UNITED STATES OF AMERICA
NUCLEAR REGULATORY COMMISSION

In the Matter of)	
)	Docket No. 50-400-LA
CAROLINA POWER & LIGHT)	
COMPANY)	ASLBP No. 99-762-02-LA
)	
(Shearon Harris Nuclear Power Plant))	
)

AFFIDAVIT OF LAURENCE I. KOPP IN SUPPORT OF THE
NRC STAFF BRIEF AND SUMMARY OF RELEVANT FACTS, DATA
AND ARGUMENTS UPON WHICH THE STAFF PROPOSES TO RELY
AT ORAL ARGUMENT ON TECHNICAL CONTENTION 2

Figure 5.6.1: Burnup Versus Enrichment for PWR Fuel

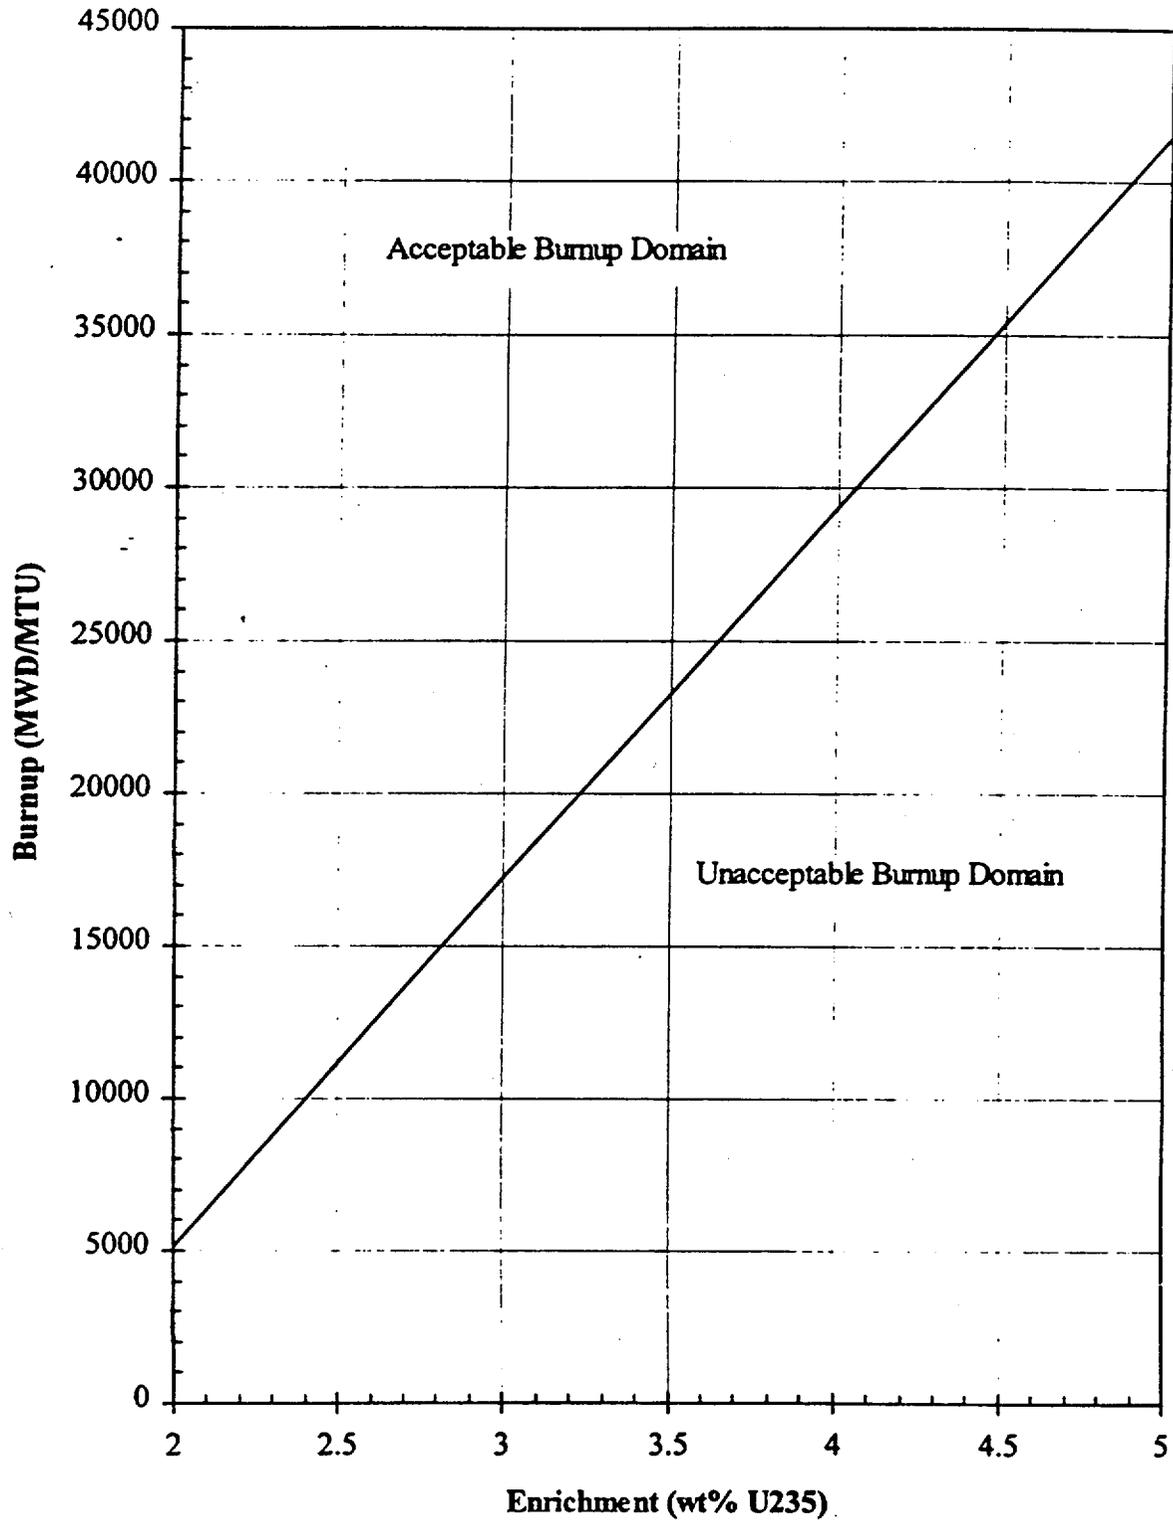
Although the burnup criteria for storage in Pools C or D will be implemented by administrative procedures to ensure verified burnup prior to fuel transfer into these pools, an administrative failure should be assumed and evaluation of a fuel assembly misloading event (i.e., a fresh pressurized-water reactor (PWR) assembly inadvertently placed in a location restricted to a burned assembly as per Technical Specifications (TS) Figure 5.6.1) should be analyzed.

How will the burnup requirements needed to meet TS Figure 5.6.1 be ascertained for fuel assemblies shipped from other PWR plants (Robinson)?

The burnup curve (proposed TS Figure 5.6.1) applies to the Robinson 15 x 15 fuel assembly types identified in Table 4.3.1 of Enclosure 6 to CP&L's license amendment request, dated 12/23/98.
